Job Number: 14_233

SUBJECT: Waikato Regional Theatre – Transportation Review

Figure 1: Pedestrian Crash Diagram (red circles indicate crashes occurring between 12midnight-1am)

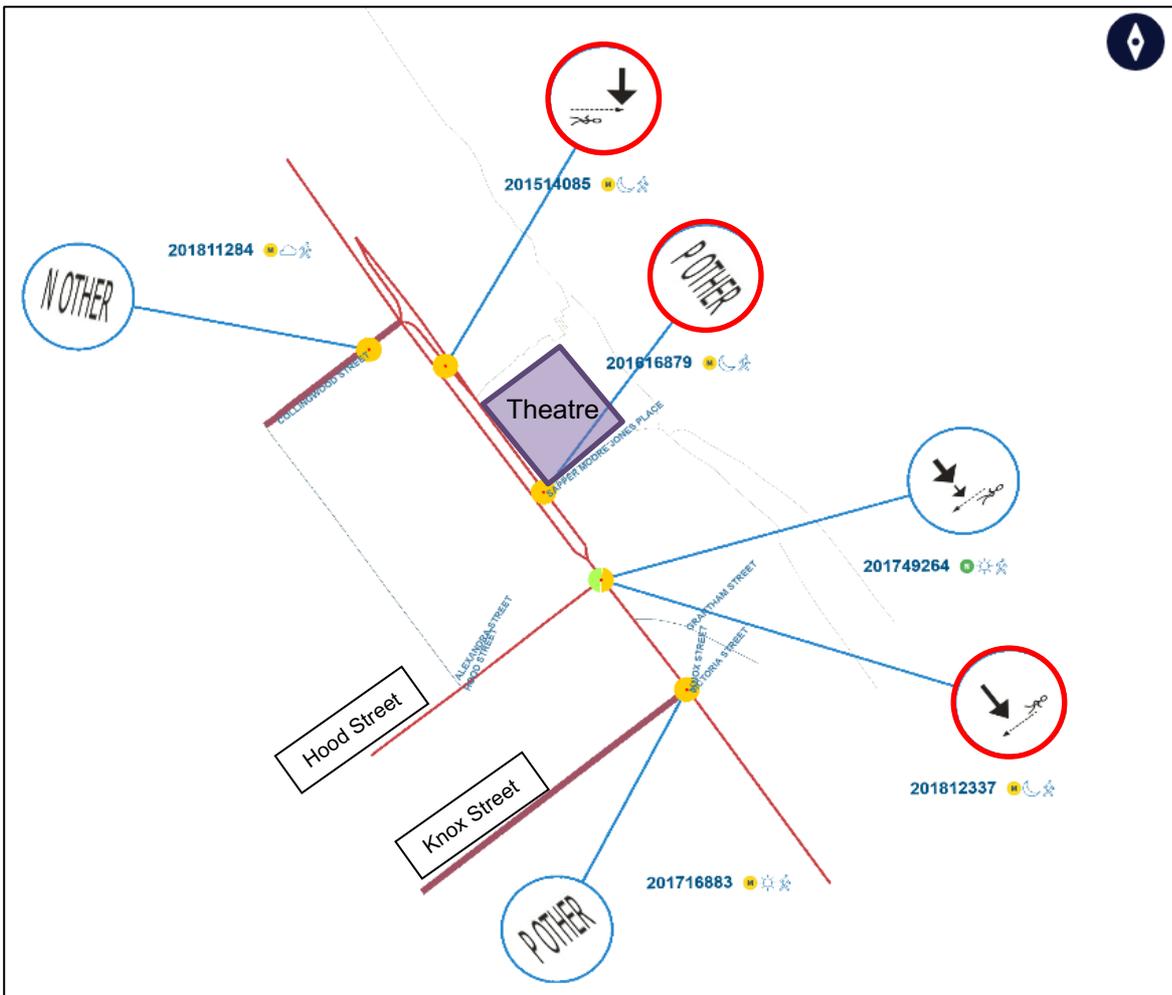
7. Mr Brandon (paragraph 5.21) identifies the trend of pedestrians being struck in the early hours of the morning.
8. In the period 2014-2019, there has been 54 reported crashes within a 250m radius of the theatre. Six crashes involved pedestrians receiving minor injuries. This includes one crash at the Victoria Street/ Sapper Moore-Jones Place intersection. Three of these pedestrian crashes occurred between midnight and 1am.

Figure 2: Average Hourly Pedestrian Count

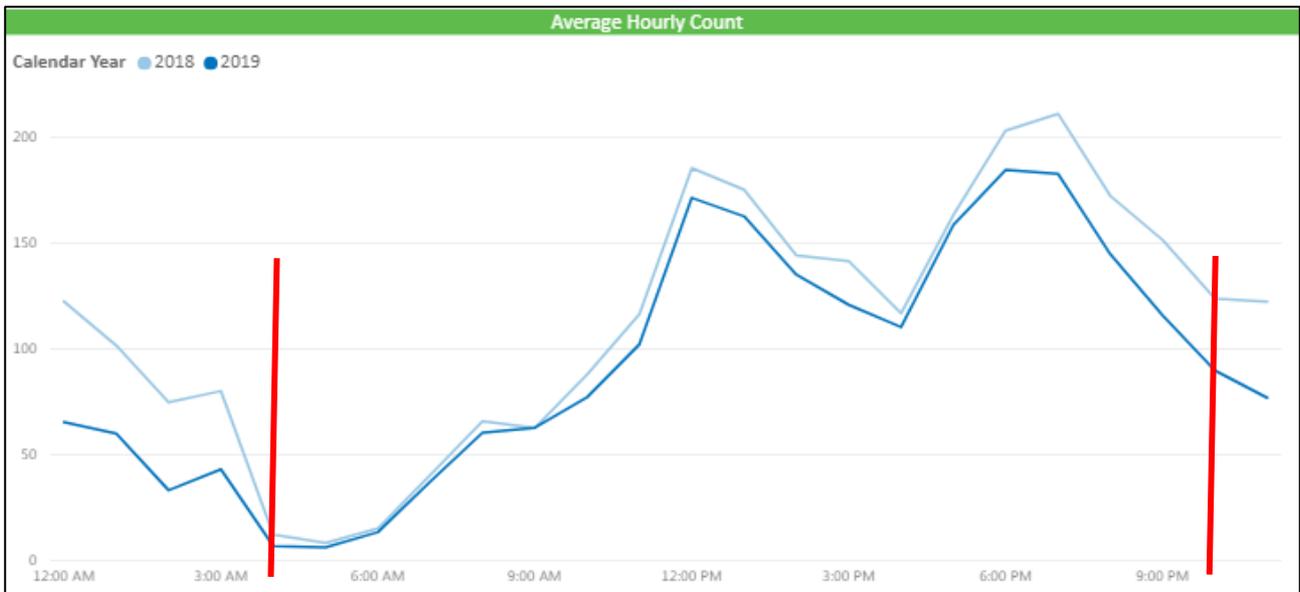
9. HCC has provided pedestrian volumes from a counter located on eastern (river) side Victoria Street, approximately 40m north of Sapper Moore-Jones Place. These counts show:
 - a) A 17% reduction in pedestrians between 2018 and 2019. This is likely due to closure of the previous tenants of the site including Bar 101 and Easy Tiger in September 2018.
 - b) The 2018 counts in the period 10pm-4am were approximately double the 2019 counts
 - c) Based on September 2019 counts:
 - a. Hourly average of 92 pedestrians/hour
 - b. Average of 61 pedestrians/hour between 10pm and 4am
 - c. Peak hours occur 12midday-2pm (167 pedestrians/hour) and 6-8pm (184 pedestrians/hour)

10. In summary, the counts show that there are relatively high pedestrian movements in this section of Victoria Street between 10pm and 4am, especially when there has been bar activities operating from the proposed site.
